**Blackmoorfoot Road, Huddersfield  
Proposed Internal Layout (Vistry Parcel)  
Stage 1 Road Safety Audit**

October 2025 (Initial Issue)

Prepared on behalf of  
**Vistry Yorkshire**

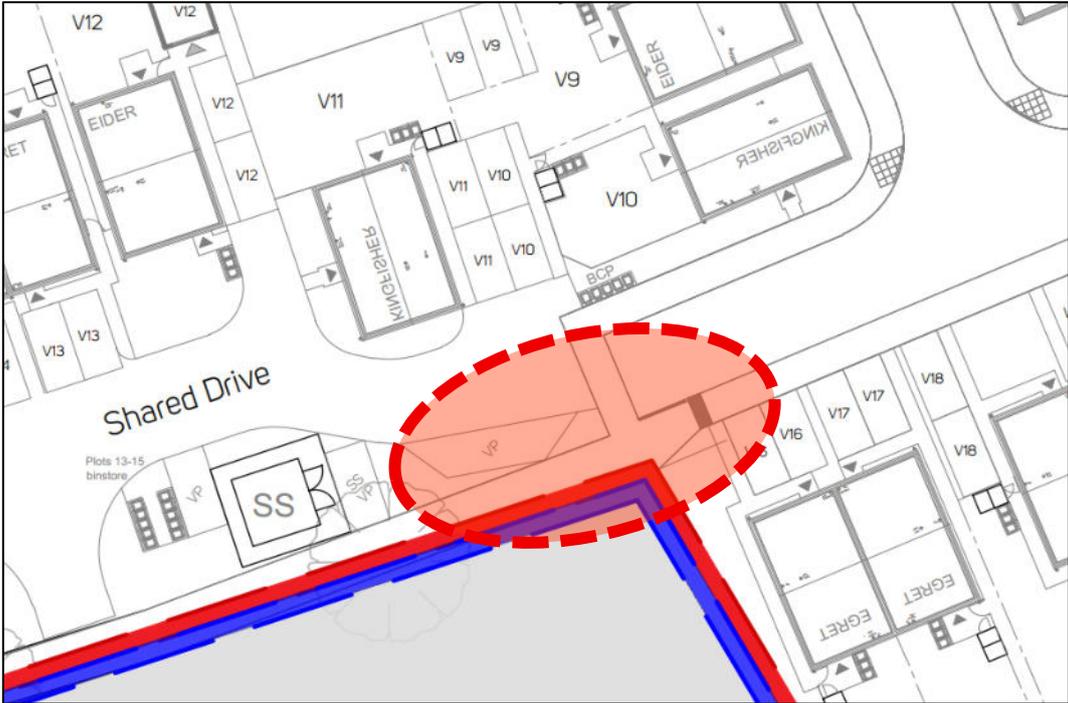
PROBLEM	
<b>Location</b>	Private drive serving plots 10-15 (at the head of Road V3).
<b>Summary</b>	The proximity of the turning head may conflict with users of the shared footway/cycleway.
<p>A private drive serving plots 10-15 forms a turning facility immediately adjacent to the shared footway/cycleway connecting the Millers parcel with Road V3.</p> <p>The proximity of the turning head to the path may result in larger vehicles reversing back onto or overhanging the shared footway/cycleway and increases the risk of a collision with a pedestrian or cyclist.</p>

<b>Recommendation</b>	It is recommended that a suitable vehicle restraint barrier is provided between the shared footway/cycle and the turning head. Alternatively, it is recommended that the layout/design of the turning facility is amended to provide adequate separation.

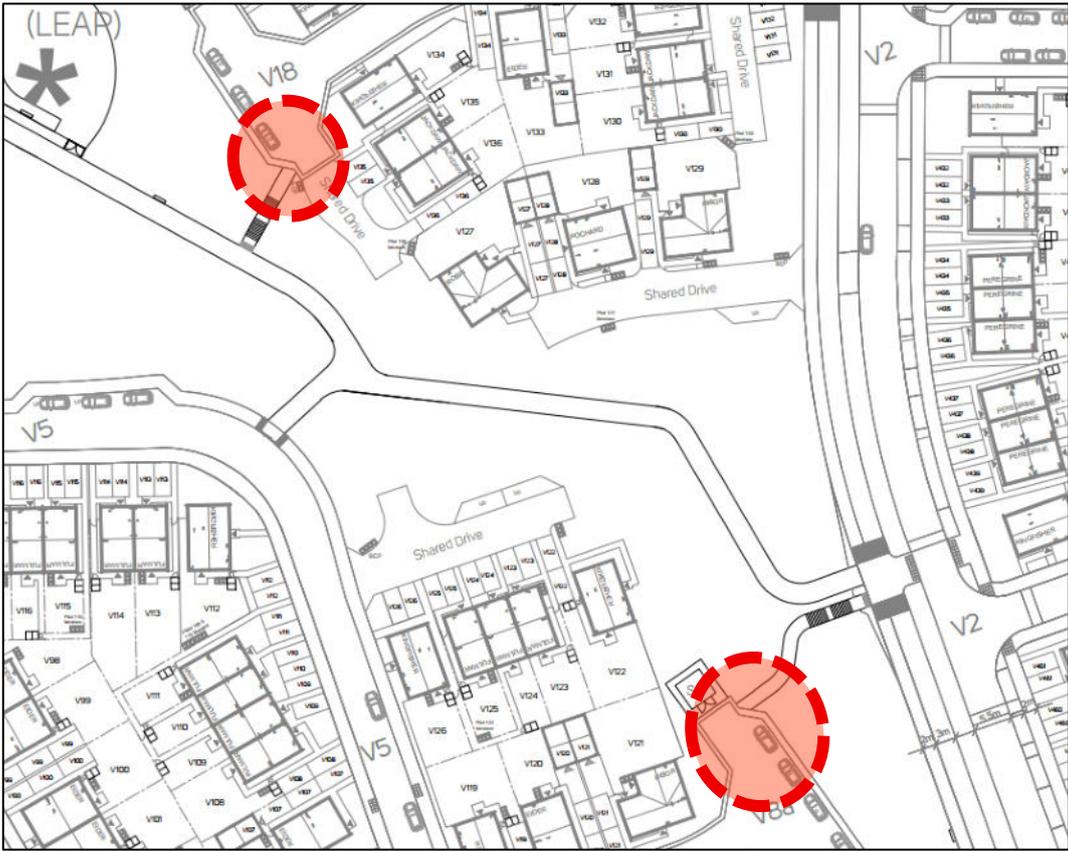
PROBLEM	
<b>Location</b>	Shared footway/cycle between plots 16 and 10 (Road V3).
<b>Summary</b>	Cyclists may discharge into the carriageway into the path of oncoming traffic.
<p>The shared footway/cycleway connecting the Millers parcel with Road V3 terminates opposite plot 16, where the traditional estate road meets a private drive. The private drive incorporates a formal visitor car parking space, which when occupied, may obstruct visibility to a cyclist when travelling eastbound parallel to one another.</p> <p>Although it is acknowledged that vehicular speeds may be low, the restricted visibility between an eastbound vehicle emerging from the private drive and an eastbound cyclist (particularly a child), could increase the risk of a collision as the cyclists discharges onto the carriageway.</p>

<b>Recommendation</b>	
It is recommended that the visitor parking bay is relocated or removed to provide suitable intervisibility between the private drive and shared footway/cycleway.

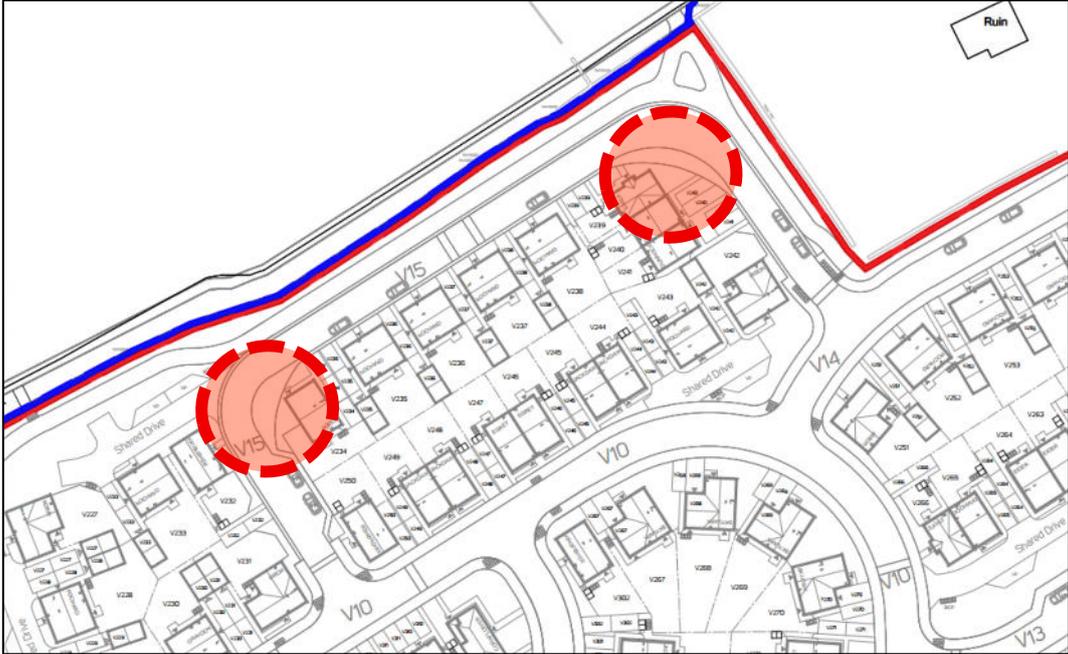
PROBLEM	
<b>Location</b>	Bin collection point adjacent to plot 10 (Road V3).
<b>Summary</b>	The bin collection point restricts visibility from the driveway.
<p>A bin collection point is provided adjacent to plot 10, immediately to the east of the driveway. The bin collection point would be located within the pedestrian intervisibility splay. When occupied, the presence of the bins would likely block visibility between pedestrians on the footway and an emerging vehicle from the driveway, increasing the potential for a collision.</p>	
<b>Recommendation</b>	
<p>It is recommended that the bin collection point to the rear of the substation is enlarged to provide a single bin collection point for plots 10-15.</p>

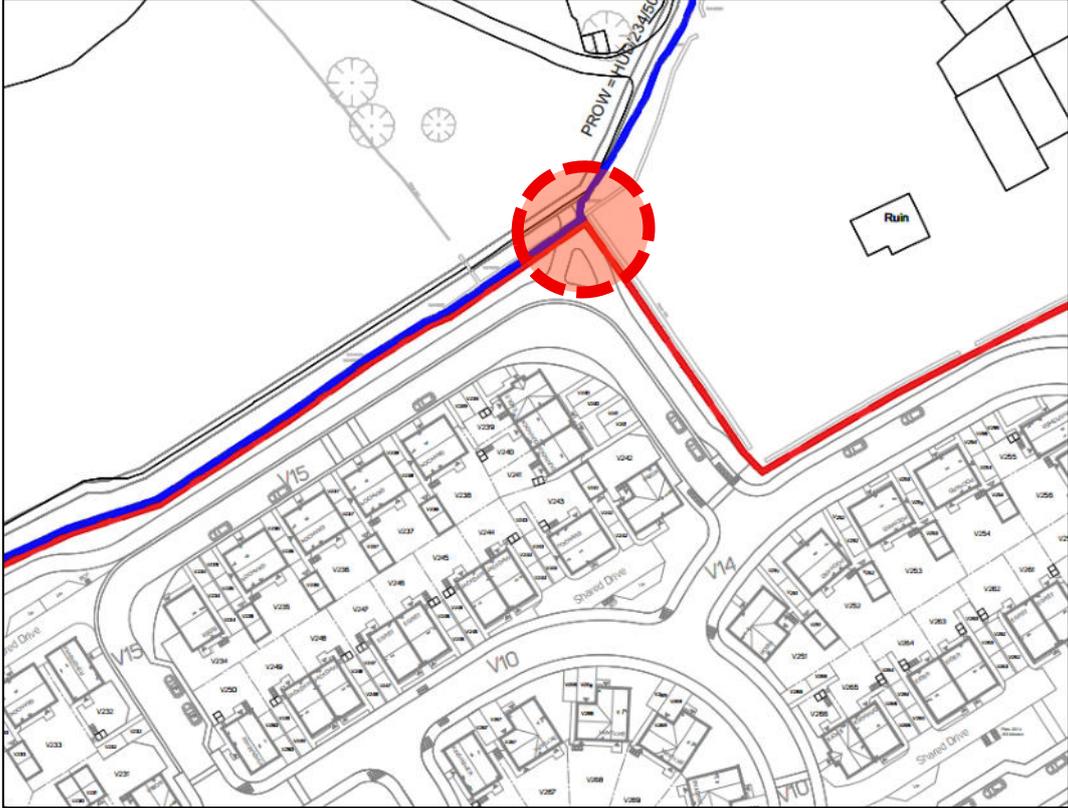
PROBLEM	
<b>Location</b>	Footpath connection opposite plots 121 and 134.
<b>Summary</b>	A pedestrian may be struck when emerging from the footpaths.
<p>A pedestrian footpath is provided between road V2 and V8a (opposite plot 121) and between road V18 and the play area (opposite plot 134). Both footpaths emerge onto shared surfaces in close proximity to parking laybys and a bin collection point is also located immediately to the east of the connection onto road V18.</p> <p>When occupied, the parking laybys (and bin collection point) are likely to restrict visibility to/from the footpath connection, particularly to smaller children. Although it is acknowledged that speeds will be very low, as reversing vehicles will be a common occurrence within the turning heads, there is a risk of a collision between a pedestrian and reversing vehicles.</p>

PROBLEM	
<b>Location</b>	Shared surface road V15 opposite plots 234 & 239.
<b>Summary</b>	Parking may occur on the widened margins.
<p>Widened hard margins have been provided on the inside of the two ninety degree bends along road V15, adjacent to plots 234 and 239 in order to accommodate forward visibility.</p> <p>Based on the drawings provided, this appears to be a widened hard margin. The widened area, may be used for parking, which would restrict forward visibility and potentially obstruct larger delivery or refuse vehicles, resulting in a potential vehicle-vehicle or vehicle-pedestrian collision.</p>

<b>Recommendation</b>	
<p>It is recommended that pedestrian visibility splays are provided from the crossing position and the visitor parking bays and bin collection point are relocated accordingly.</p>

<b>Recommendation</b>	
It is recommended that measures are introduced in order to prevent parking within the forward visibility splays at the detailed design stage.

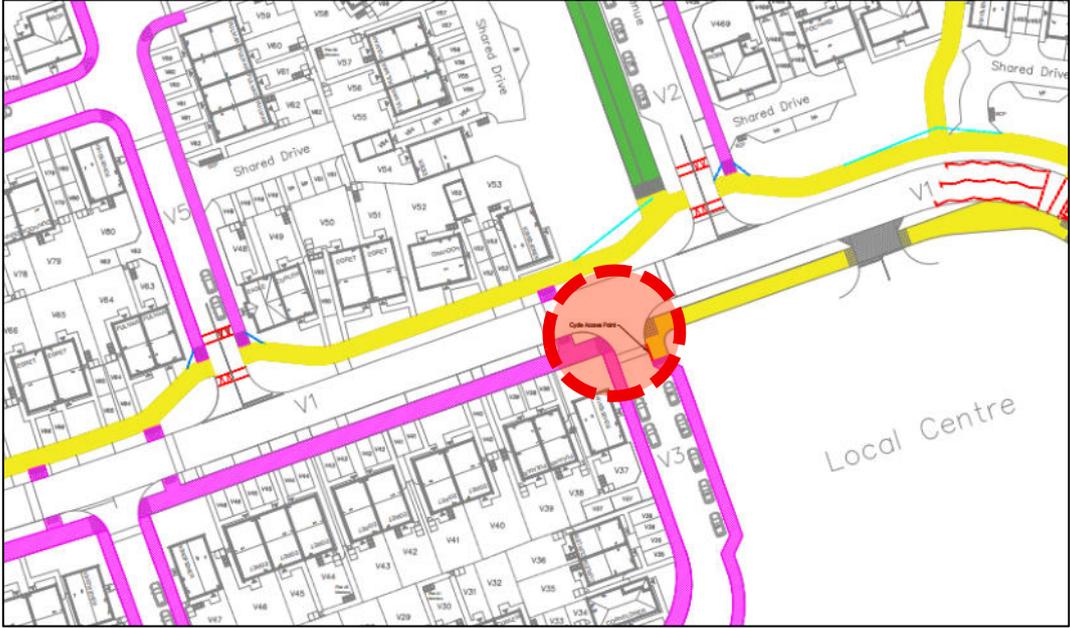
PROBLEM	
<b>Location</b>	Shared footway/cycleway connecting to PRow HUD/234/50
<b>Summary</b>	Cyclists may use the footpath.
<p>A shared footway/cycleway is provided at the northeastern corner of the development which connects to PRow HUD/234/50, which is a footpath. No hazard warning paving has been provided, which may encourage cyclists to cycle along the footpath in conflict with pedestrians.</p>

<b>Recommendation</b>	
<p>It is recommended that end of cycleway signage and hazard warning paving is provided at the detailed design stage.</p>
